# DEVELOPMENT REVIEW BOARD REPORT

MEETING DATE: September 22, 2005

CASE NUMBER/ PROJECT NAME	<b>87-DR-2004#2</b> <b>Bank Of America At Hayden Peak Crossing</b>		
LOCATION	Southeast corner of Hayden Road & Thompson Peak Parkway		
REQUEST	Request approval of a site plan, elevations and landscaping for a new bank branch in the Hayden Peak Crossing shopping center within the Grayhawk community.		
OWNER	Jones Lang Lasalle Americas 602-523-6640	ENGINEER	Norman Engineering Group Inc. 602-371-0397
ARCHITECT/ DESIGNER	Gensler 602-523-6152	APPLICANT/ COORDINATOR	Scott McCage Gensler 602-523-6152
BACKGROUND	<p><b>Zoning.</b> Adjacent Uses:</p> <ul style="list-style-type: none"><li>• North: Multi-family residential, zoned R-4 PCD ESL (Townhouse residential, Planned Community Development, Environmentally Sensitive Lands)</li><li>• East/South: Single-family residential, zoned R1-5 PCD ESL (Single-family residential - 4,700 square feet, Planned Community Development, Environmentally Sensitive Lands)</li><li>• West: Unimproved park and open space, zoned OS PCD (Open Space, Planned Community Development)</li></ul> <p><b>Context.</b> The site is located at the southeast corner of Hayden Road and T

# **SITE PLAN**

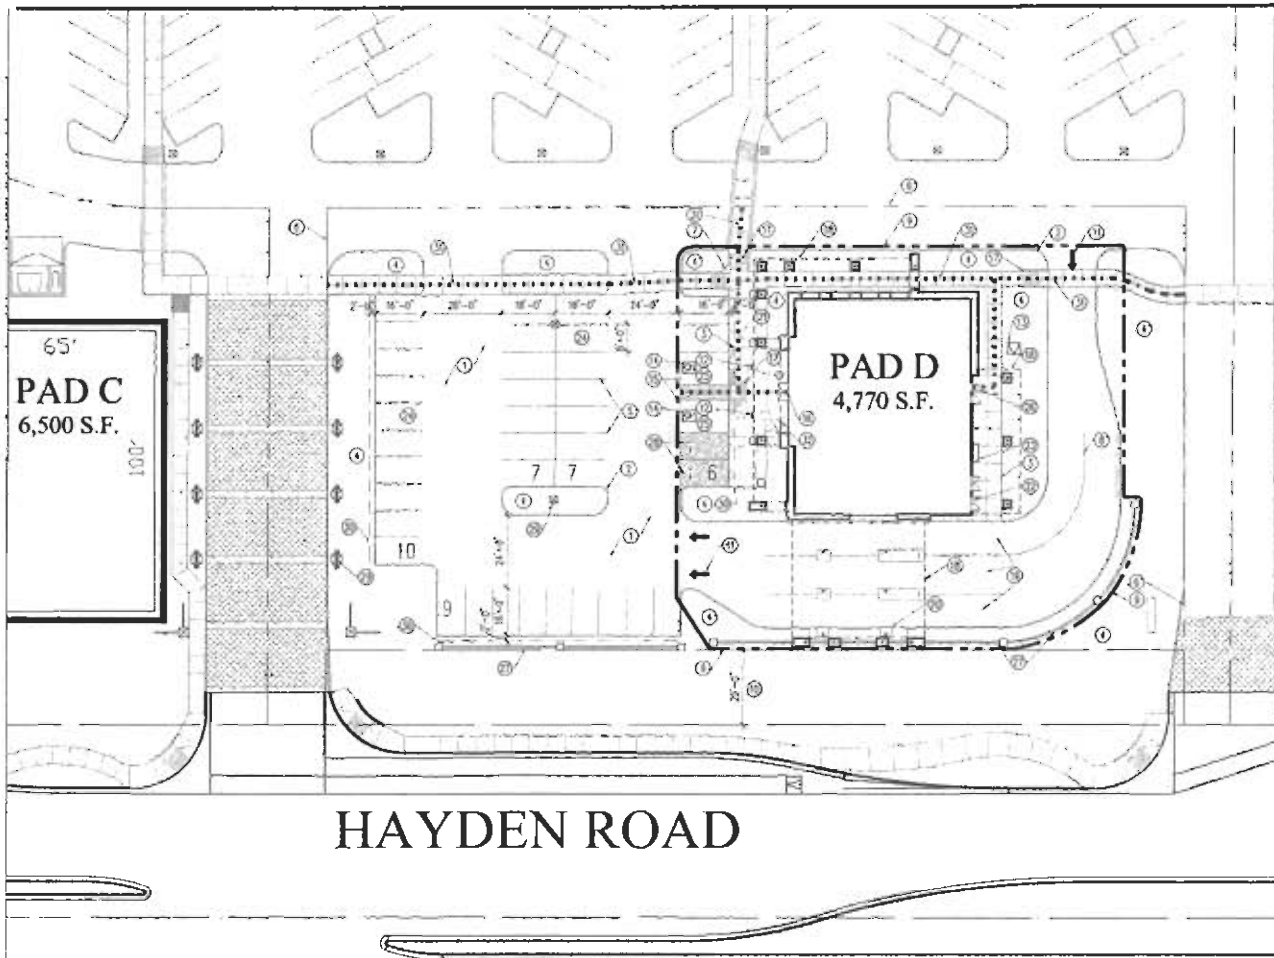
Two suggestions were made by staff upon initial review of the proposed design: Move the drive-through service so that it is oriented on another side of the building rather than the street (Commercial Design Guidelines #1 and 2 above),

and provide additional architectural treatment to the drive-through canopy to better address Commercial Design Guideline #3 above. Although recommended, the applicant did not reorient the building. Several banks have been built with the drive-through exposed to public views. In this case, staff finds no design or traffic circulation constraints on the site that would prohibit the reorientation of the building to meet the Commercial Design Guidelines.

As an alternative to relocating the drive-through, staff suggested to the applicant that a solid wall with decorative openings be provided along the west side of the drive-through canopy. The applicant responded by designing a wall extending approximately 1/3 below the roofline with wide columns along the west side of the canopy. This may be adequate to screen the drive-through from public view, but it is not the ideal solution.

9. *Proposed screen wall located between the drive thru and Hayden Road shall match the screen walls approved under 87-DR-2004.*
